SUNDRY NOTICES AND REPORTS ON WELLS
Do not use this form for proposals to drill or to re-enter an abandoned well. Use form 3160-3 (APD) for such proposals.

Cimarex Energy Co. respectfully requests to run Bulk Lines instead of Flowline and to upsize the gas lift line.

CIMAREX ENERGY CO.
 VACA DRAW 20-17 FEDERAL
 FLOW LINE NETWORK ON BLM LANDS IN
 SECTION 20, T25S, R33E, N.M.P.M.
 LEA COUNTY, NEW MEXICO

SURVEYED BY	R.B., M.H.	08-02-18	SCALE
DRAWN BY	L.K.	08-16-18	1" = 1000'
Flow line & Gas Lift ROW			Exhibit M & N

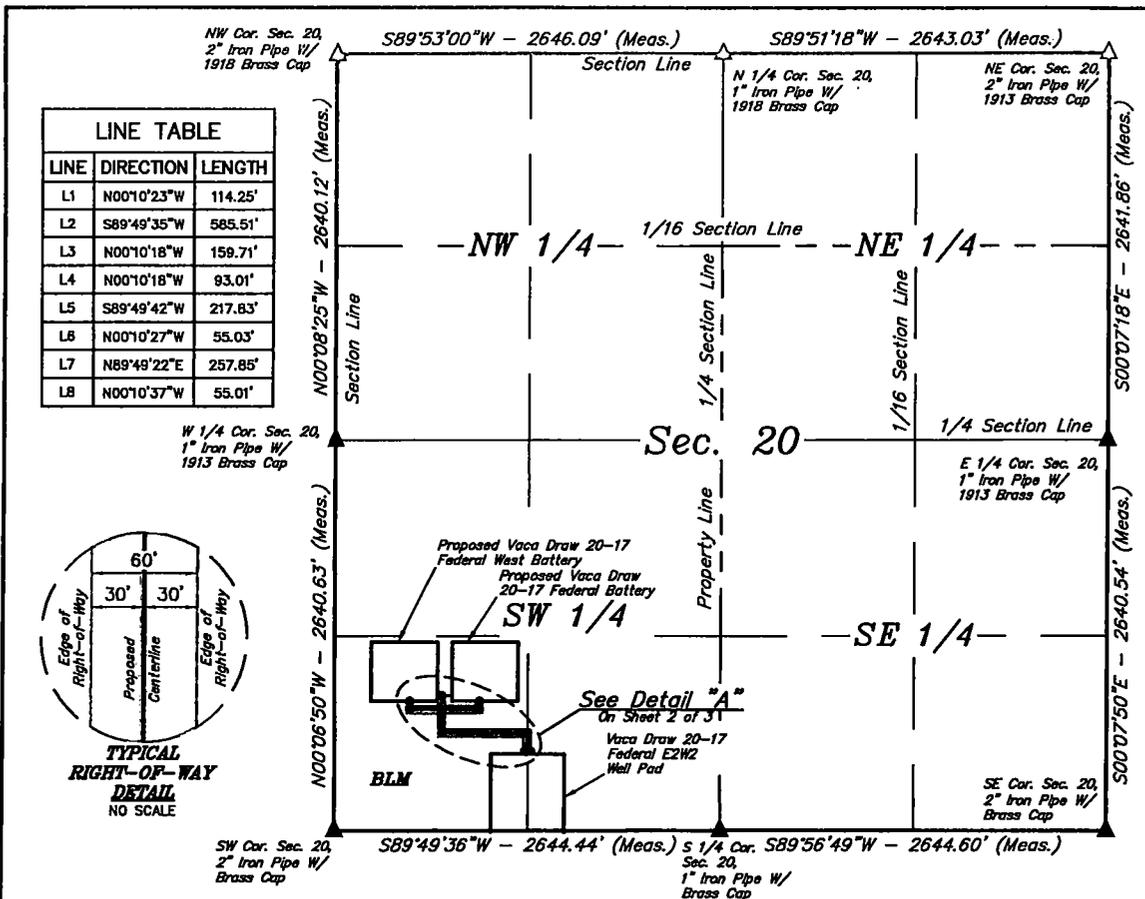
We have been working on engineering solutions to reduce our footprint in the section to lower cost, disturbance, and our economic hurdle for other marginal benches within the section to increase our total mineral recovery. It turns out that simply changing our flowline / well approach and moving our separation to our drilling pads significantly reduces our foot print and cost. By placing our separation on our drill pads we can use 6-12 Group lines to gather the separated oil gas and water from the entire section instead of using up to 90 flowlines to move production to the tank batteries for separation. The Group line ability to gather the entire section helps us eliminate 2 batteries per section by simply utilizing the group line approach.

Description of lines within the approved 60' Corridor:
Same 1538' route as analyzed and approved in the Vaca Draw 20-17 Federal 31H APD.
1- 12" Buried steel Oil Bulk line
1- 12" Buried steel Gas Sales Bulk line
1- 12" Buried steel SWD line
1- 8" Buried Steel Gas lift line

There is no new surface disturbance.
